October 24, 2012

RE: Opposition to Pacific Gas & Electric Seismic Survey: Consistency Certification and Coastal Development Permit (E-12-005 and CC-027-12).

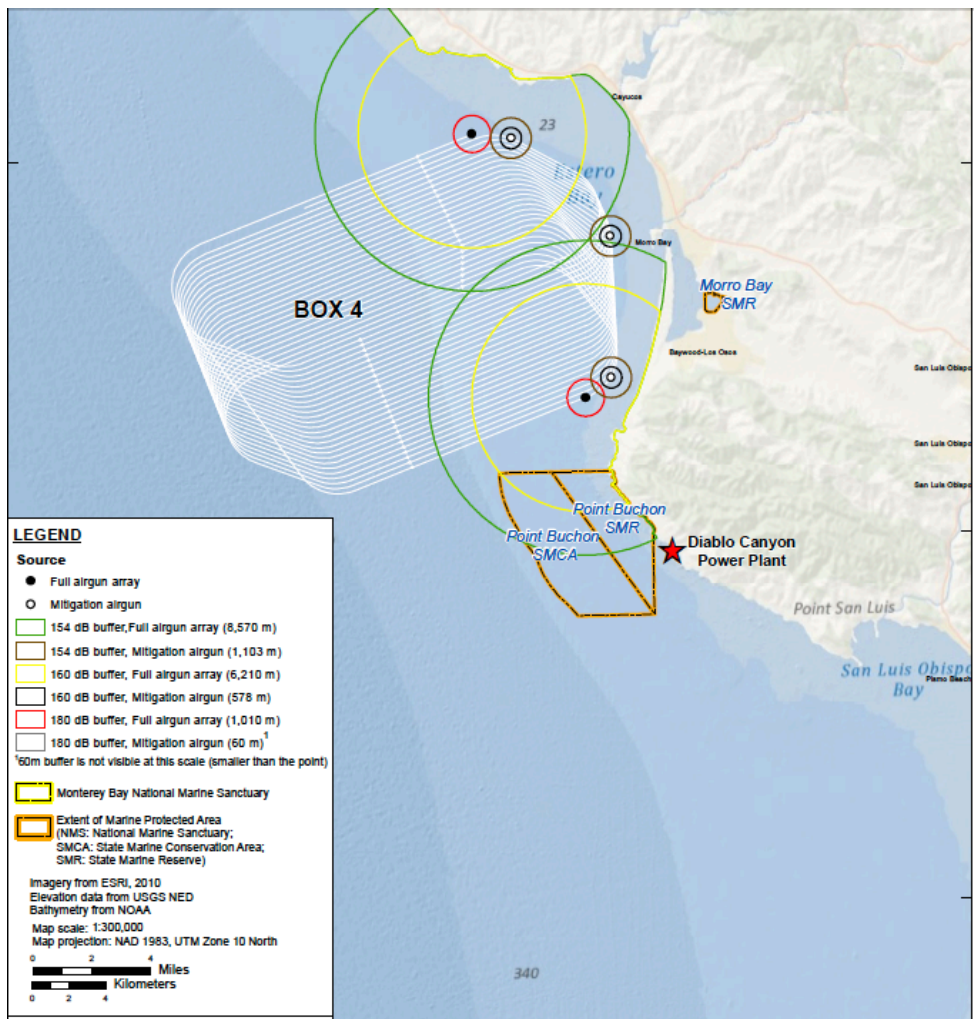
The below charts and maps (which *finally* answer the above questions) were not originally contained in the FEIR. Surfrider contacted Coastal Commission Staff asking for clarification; and in order to answer our questions, Coastal Commission Staff had to request additional information from PG&E.

It's important to reiterate the PG&E affirms 154 dB "could be harmful to swimmers and divers" ⁴.

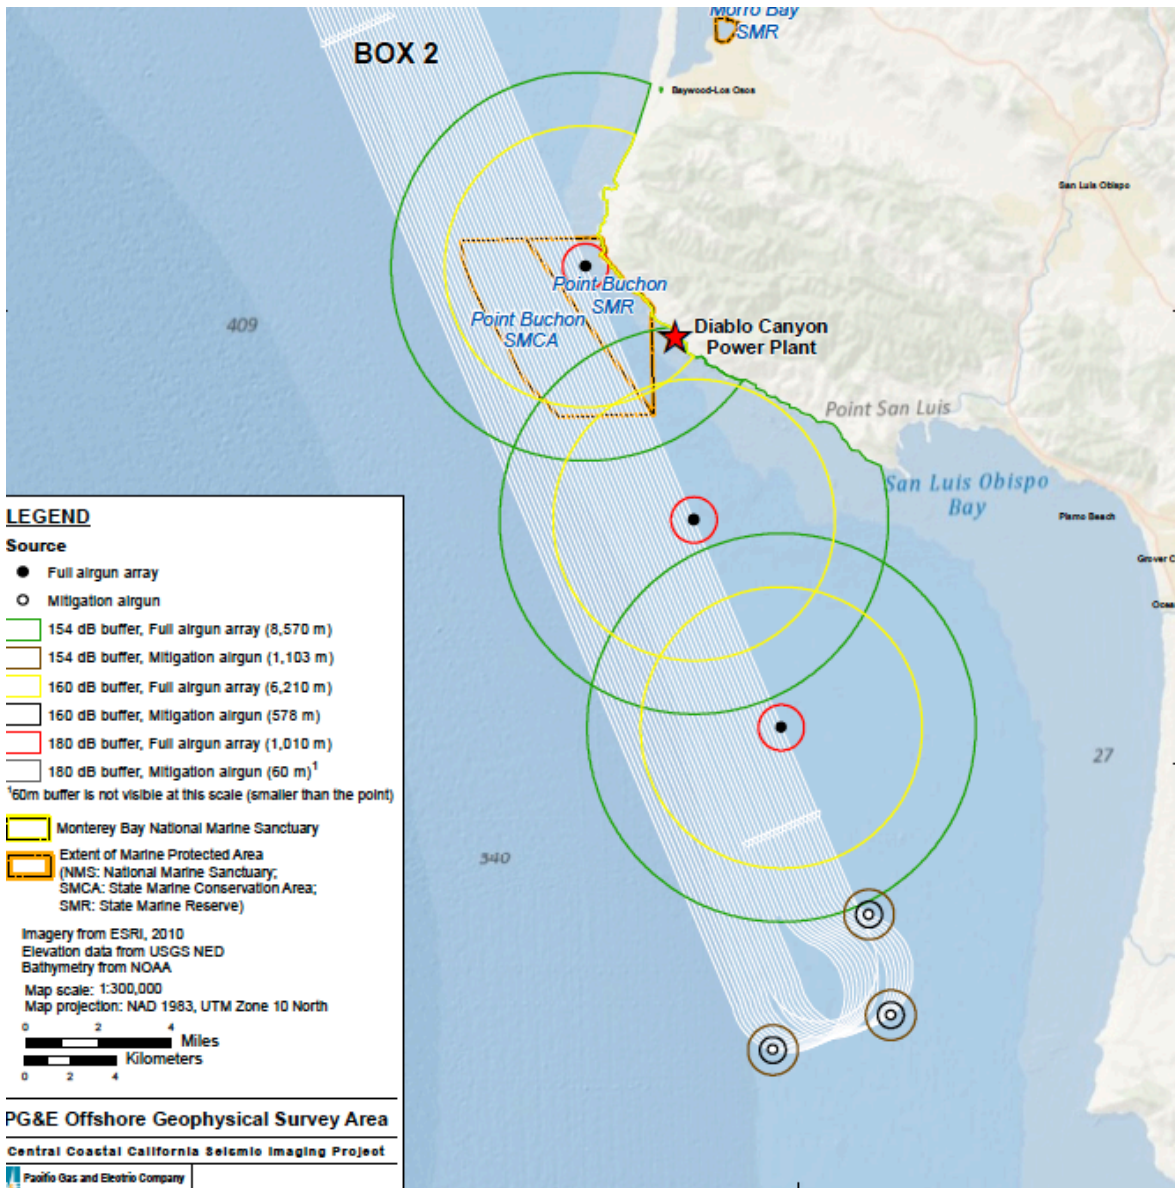
The below Project maps illustrate some beaches will receive 160 dB (yellow circles). Since dB ratios are logarithmic, 160 dB is **30 times above the safety threshold** the Navy identified at 145 dB.
